From: Manoj Nathoo (AT)
Sent: Wednesday, 30 April 2025 9:37 am
To: Siobhan O'Donovan (AT)
Subject: FW: Cross St/East St/Canada IFC

From: Putri Kusumawardhani (AT) <Putri.Kusumawardhani@at.govt.nz>
Sent: Wednesday, 12 March 2025 12:41 pm
To: Manoj Nathoo (AT) <Manoj.Nathoo@at.govt.nz>; Sophia Wang (AT) <Sophia.Wang@at.govt.nz>; Vaughn Scott (AT) <Vaughn.Scott@at.govt.nz>
Cc: Suresh Patel (AT) <Suresh.Patel@at.govt.nz>; Road Safety Engineering (AT) <RoadSafetyEngineering@at.govt.nz>; Mathew Rudez (AT) <Mathew.Rudez@at.govt.nz>; Jason Budd (AT) <Jason.Budd@at.govt.nz>; Ian Kingston (AT) <Ian.Kingston@at.govt.nz>
Subject: RE: Cross St/East St/Canada IFC

Thanks Putri and Vaughn for your valuable inputs on the design changes on Cross St. I summarised the comments/actions as listed below:

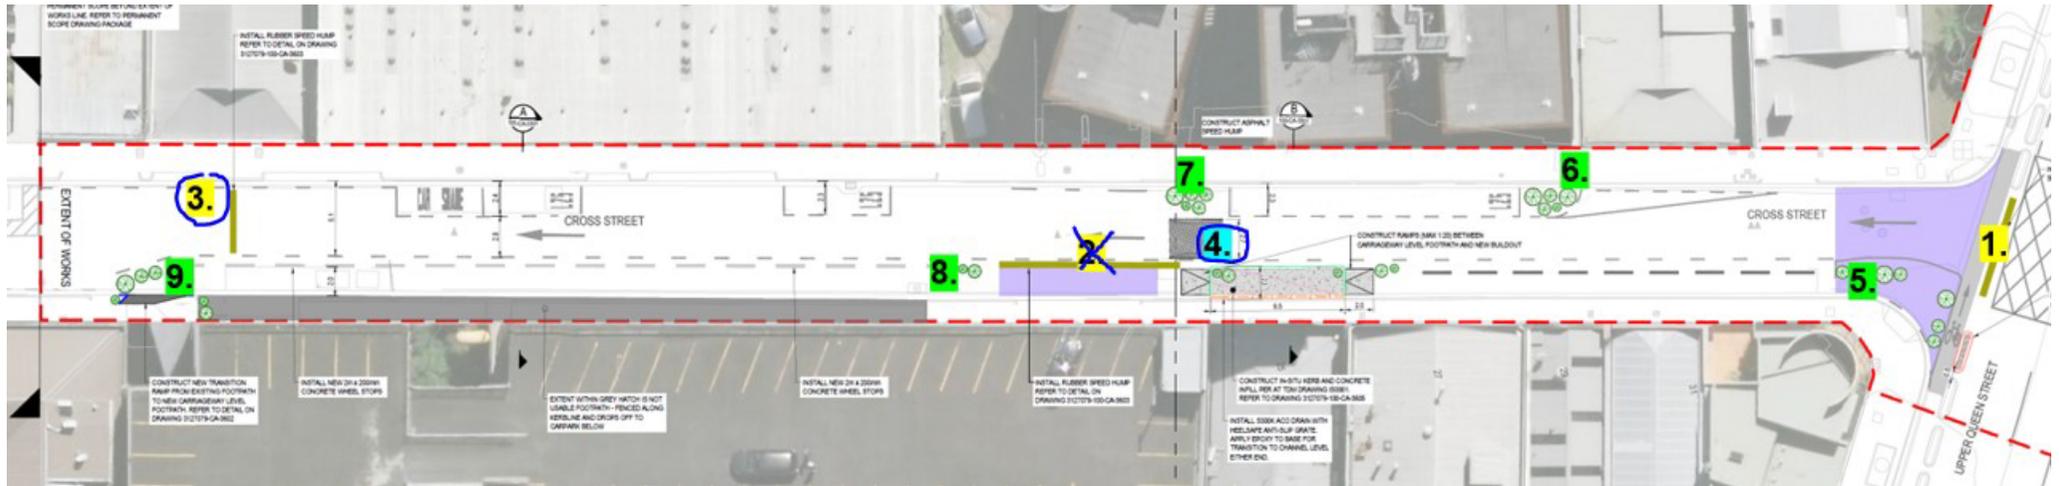
It seems that the intention is to remove all traffic calming and street furniture, including planting, which will leave the street without any improvements for walking, cycling, and general street functionality.

This will leave the street without any improvement in terms of walking/cycling and street furniture, this will leave AT with no 'place' function.

- the current speed limit and the designed operational speed on Cross St is 30km/h. **Action:** PK to confirm the acceptance of the removal of #3 and #4.

I can confirm that the removal of vertical traffic calming measures #3 and #4 is acceptable based on this existing operating speed. However, an SSA is strongly recommended to ensure safety.

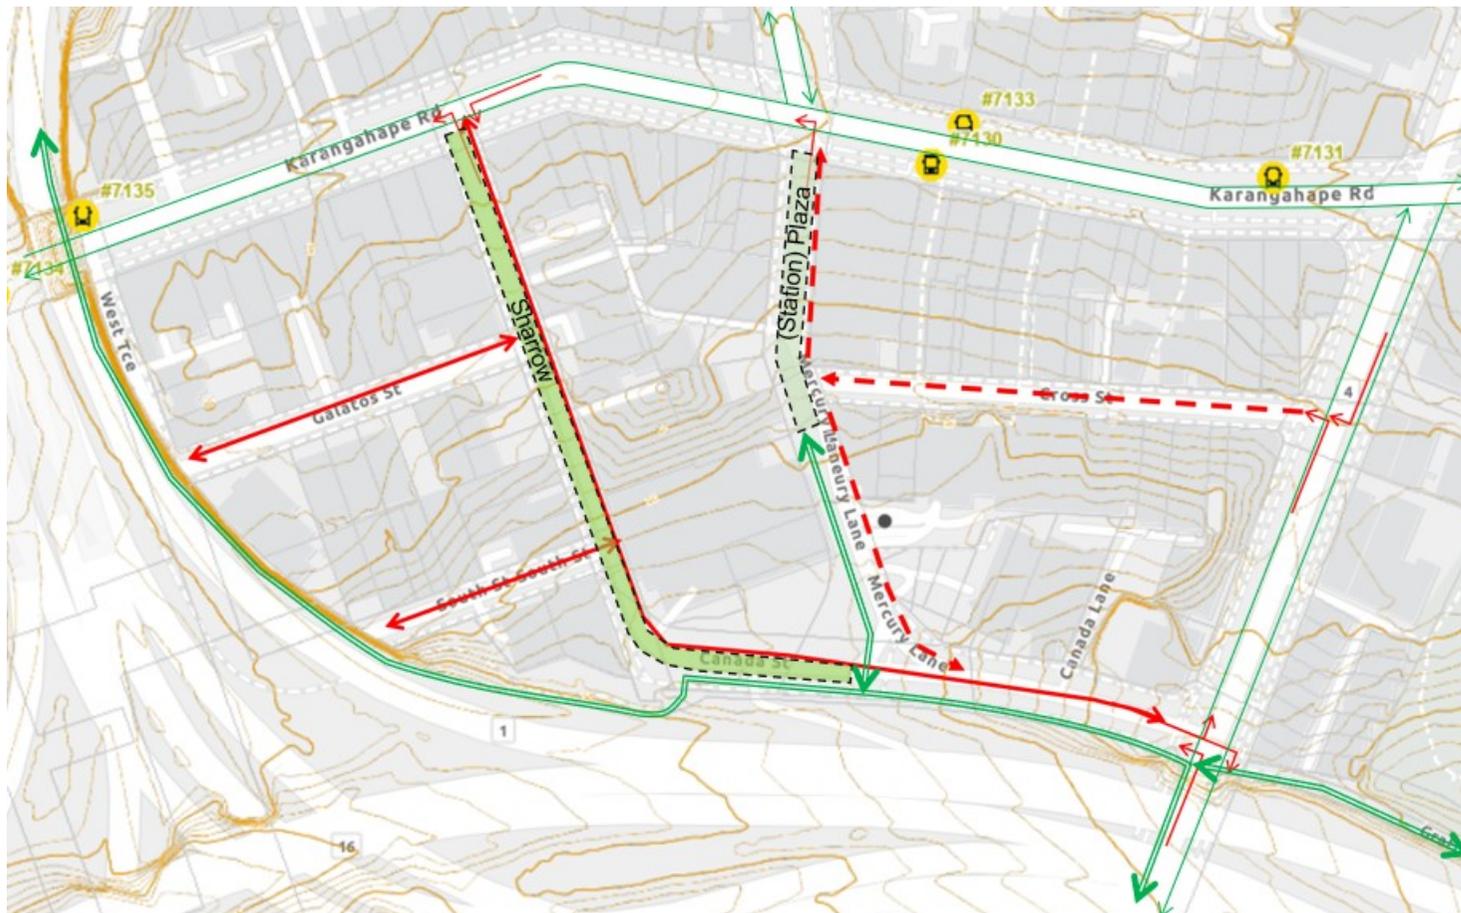
Lastly, I have a quick sketch on the current movement proposal. Is Cross St expected to serve as a kiss-and-ride facility?

Given its proximity to the station entrance, it has the potential to be a multi-modal street, catering to both active and non-active modes of transportation..

Cross St – Big Picture

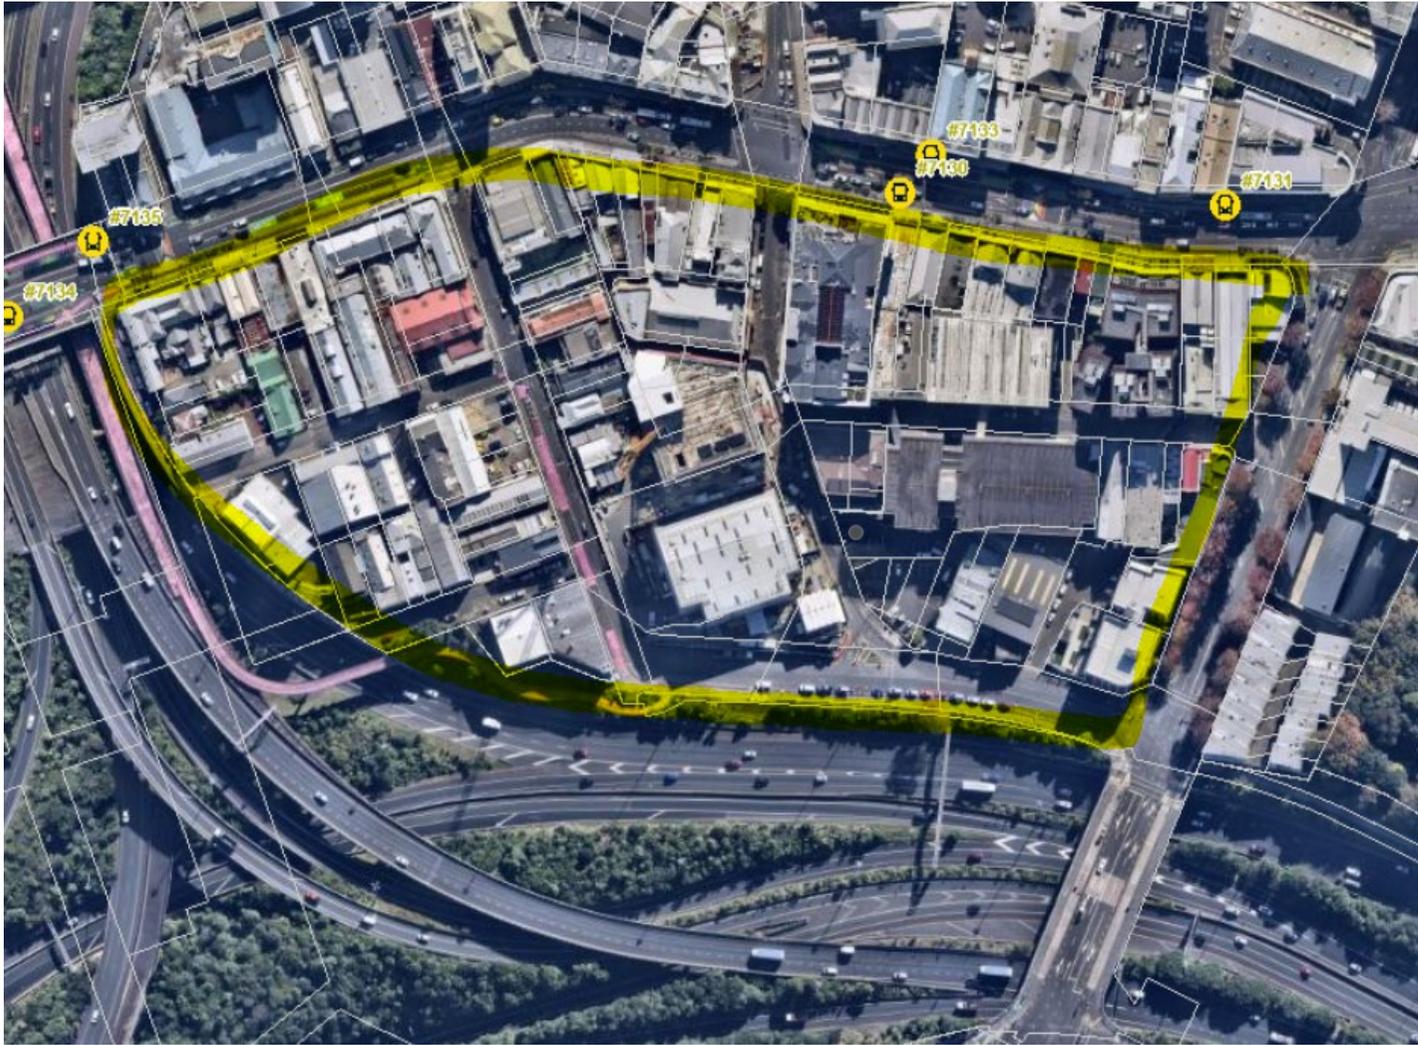
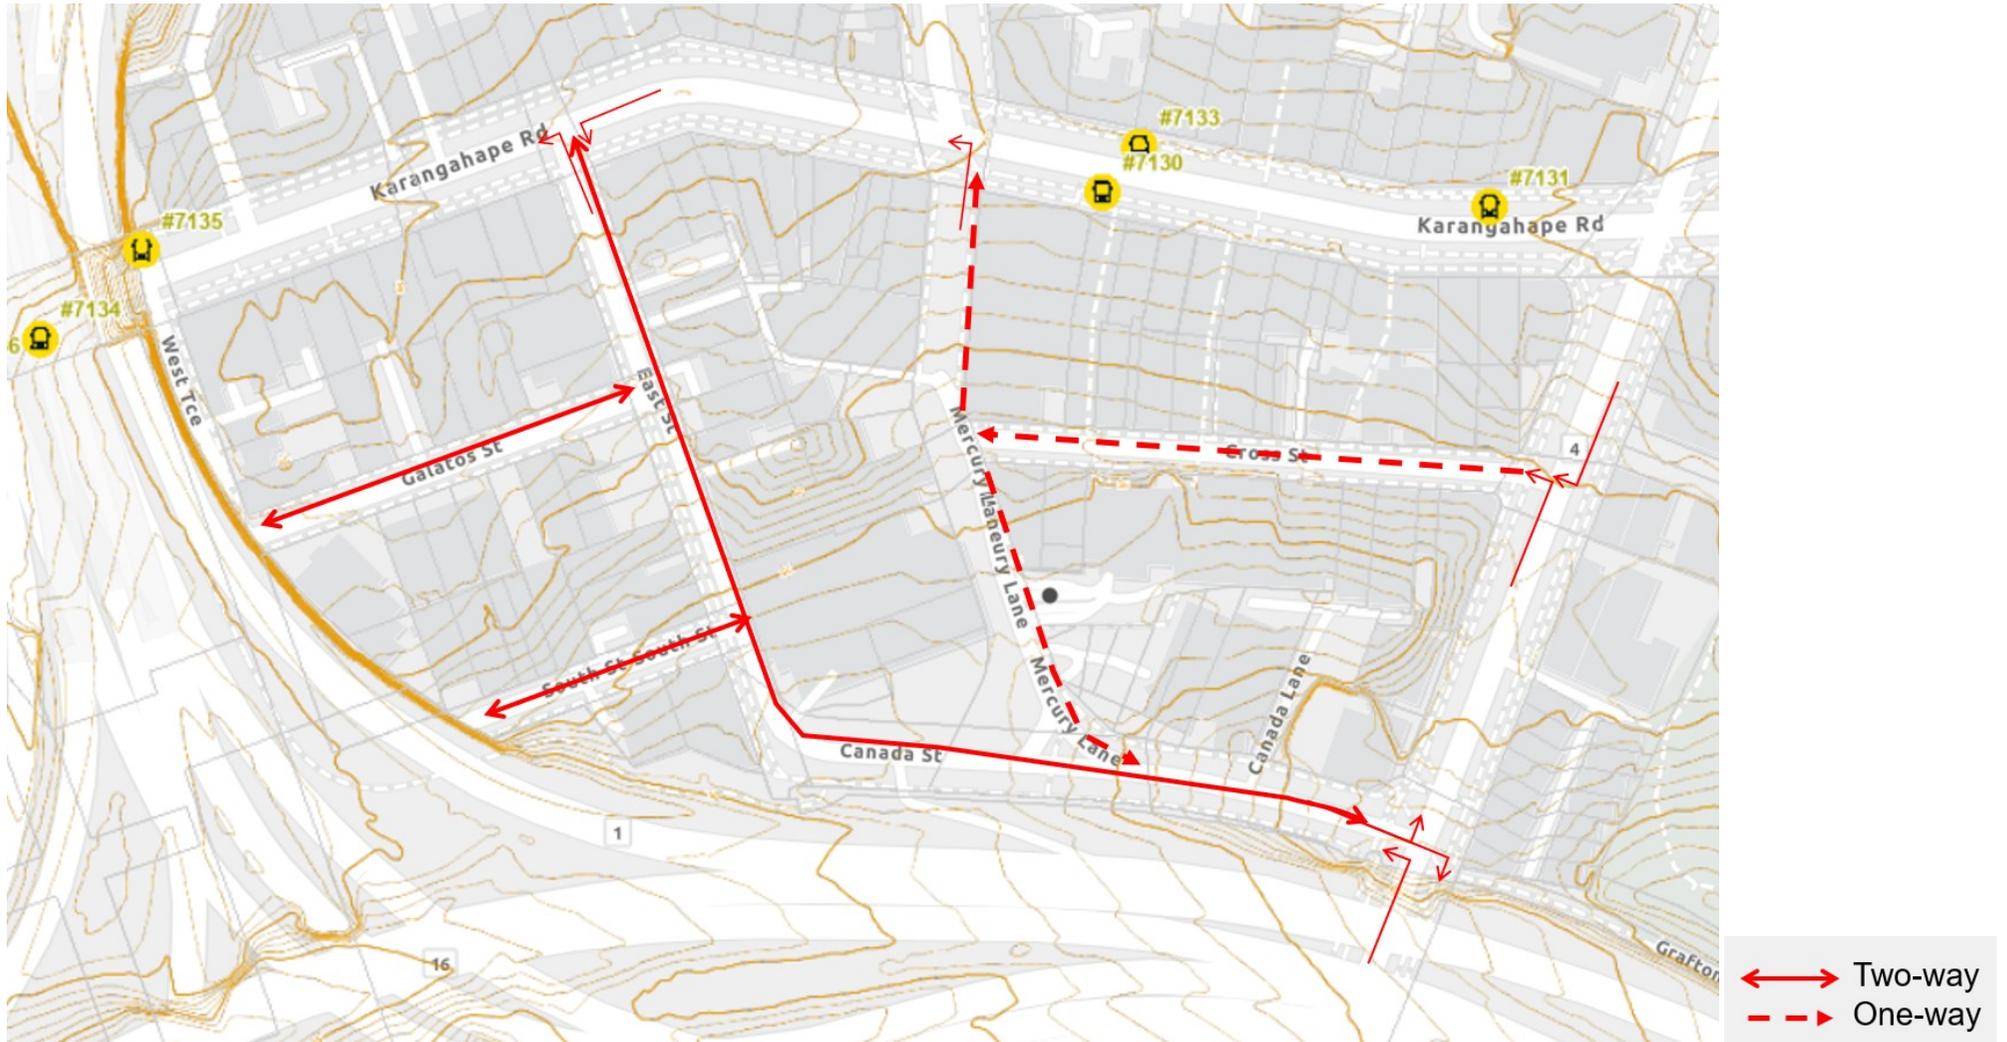
Before diving into the specifics of the design review, I would like to get a clearer understanding of the future network and current speed operating along Cross St. The recent comments from CPAG about the possibility of designating Cross St as a movement operation. While it's understandable that disabled travelers might be encouraged to head towards Beresford, given its more accessible drop and wait zone, it's important to keep in mind that Cross St holds unique significance in this area.

One crucial point to consider is that **Cross St serves as the only middle point with an accessible gradient**, thanks to its layout in the east-west direction. This makes it a vital area for travelers who require an accessible path.

Therefore, while Beresford may indeed better suit drop-off and pick-up by more active users, we should ensure that **Cross St remains accommodating for those who rely on its gradient for easier navigation**.

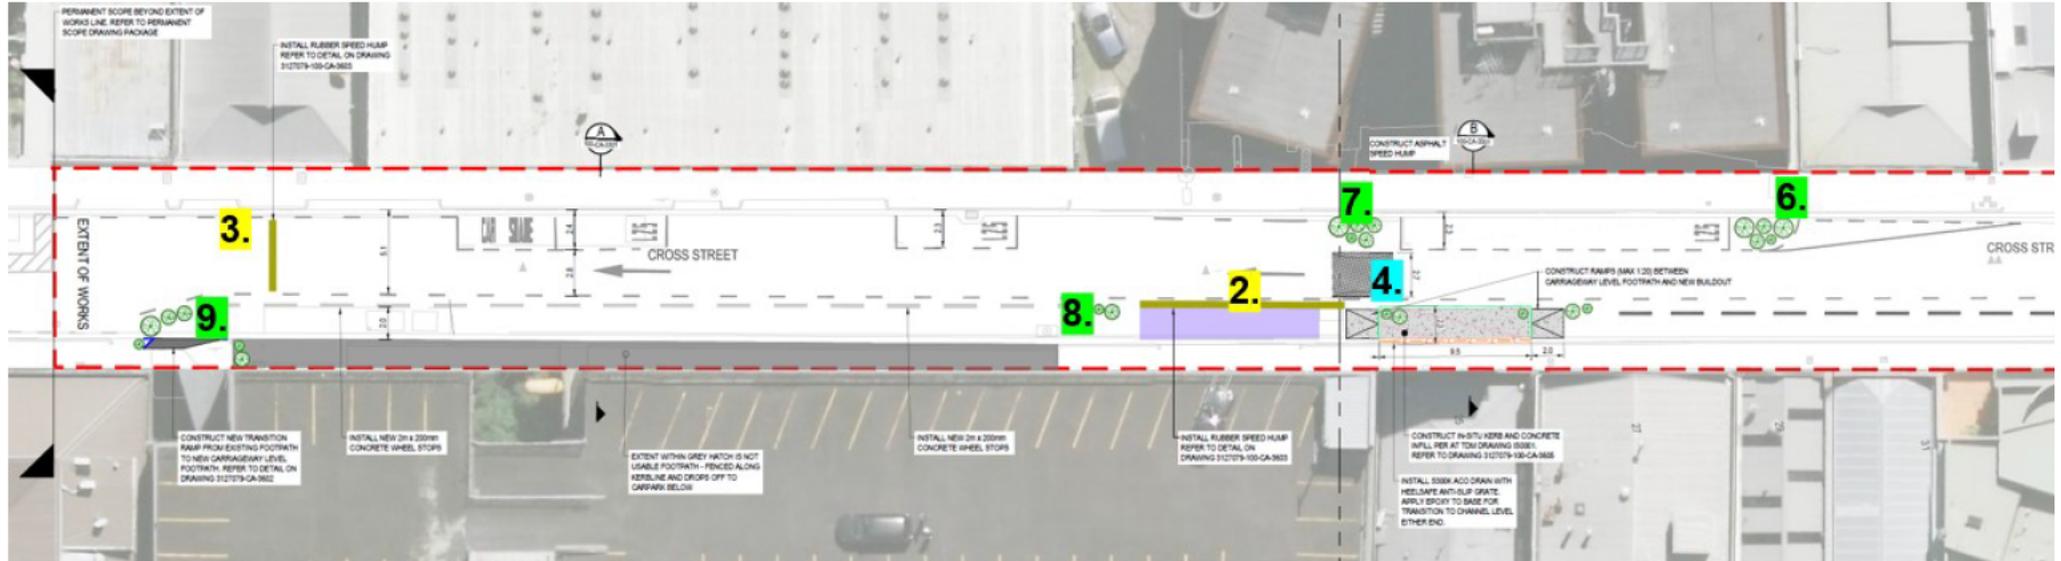
Based on the contour it seems manageable to maintain the speed along Cross St because no downhill-uphill forces. Removing the vertical features such as the speed hump and speed cushion on Cross St is acceptable if the operating speed can achieve the targeted speed around the station, which is a local road station access.

I would also like to point out that the **kerb build-out (horizontal features), still needs to be included on the design.**

It helps to create a clear delineation between the live traffic lane and the kerb-side loading or parking activity (when there is no loading/parking vehicle).

Rubber speed hump

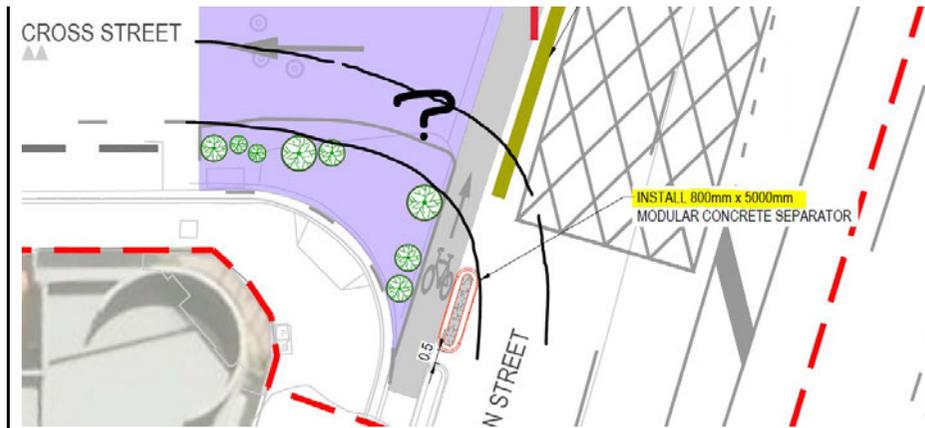
Rubber speed hump#1 – can be removed

Located in the intersection, a tight turning radius has already helped reduce/manage the speed (retain the additional 800mm concrete separator and planter box #5).

Speed cushion

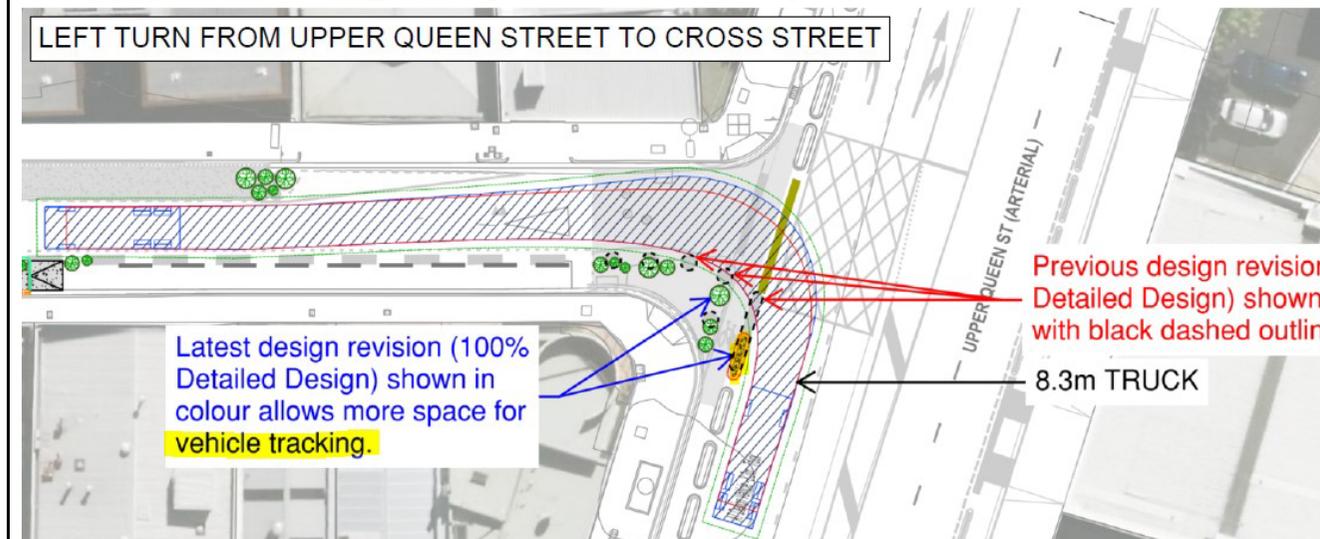
- 4 (only one between $\pm 55m$ and $\pm 65m$ distance to both of speed humps)
- Subject to operating speed (however tend to agree on managing speed in this area)
- also can be achieved by having kerbside activity (loading zone, a)

Rubber speed hump#2 – can be removed

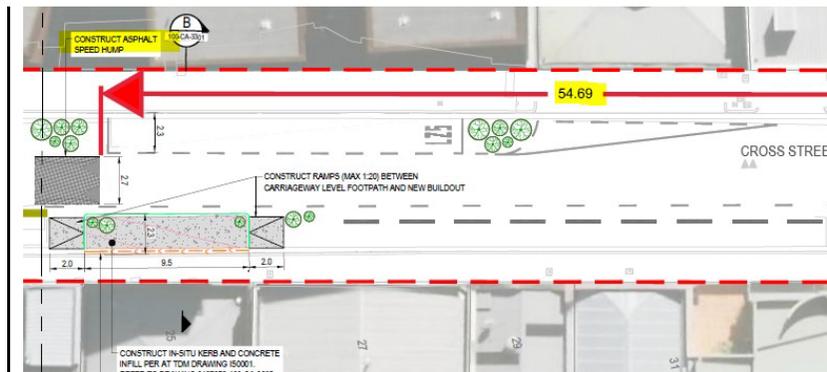
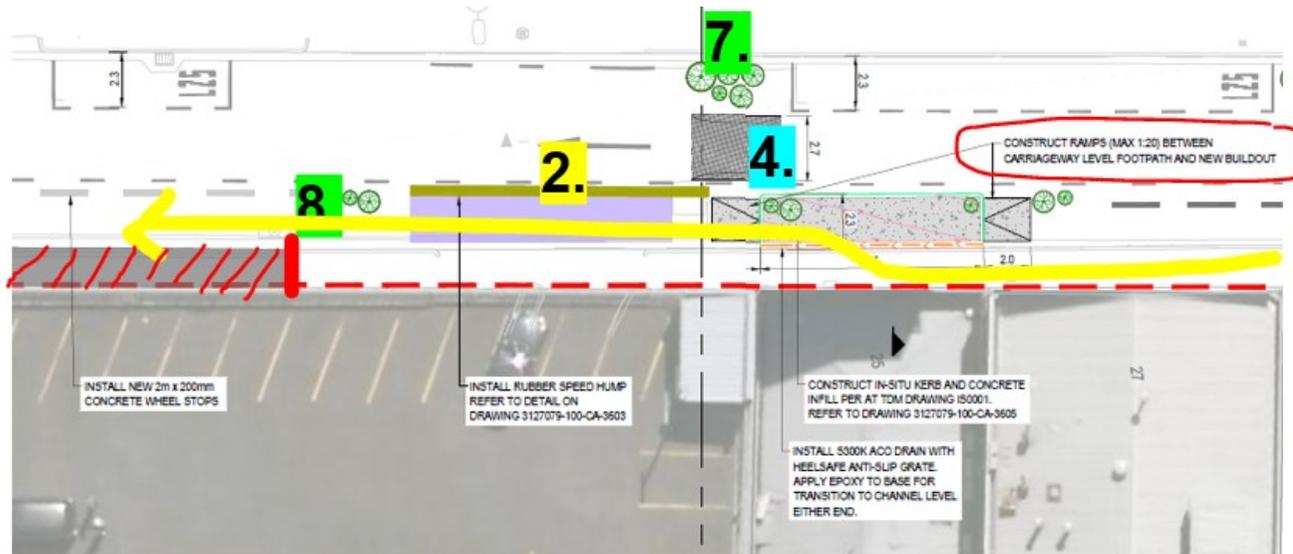
Previously served the shifting of pedestrians from the kerb build-out (see yellow line), the rubber hump is an additional design treatment to ensure drivers slowly enter the car park building.

Rubber speed hump#3

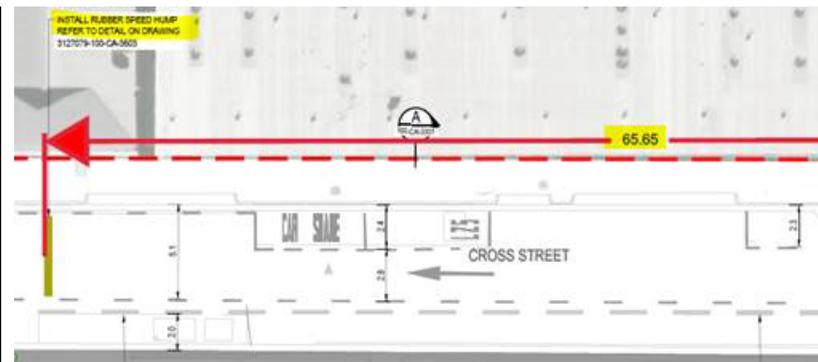
Vertical treatment to manage speed spacing every 60m for 30km/hr? **Subject to operating speed**
(however tend to agree more on managing the speed by narrowing the street using horizontal features such as planter boxes instead of vertical features - speed humps).
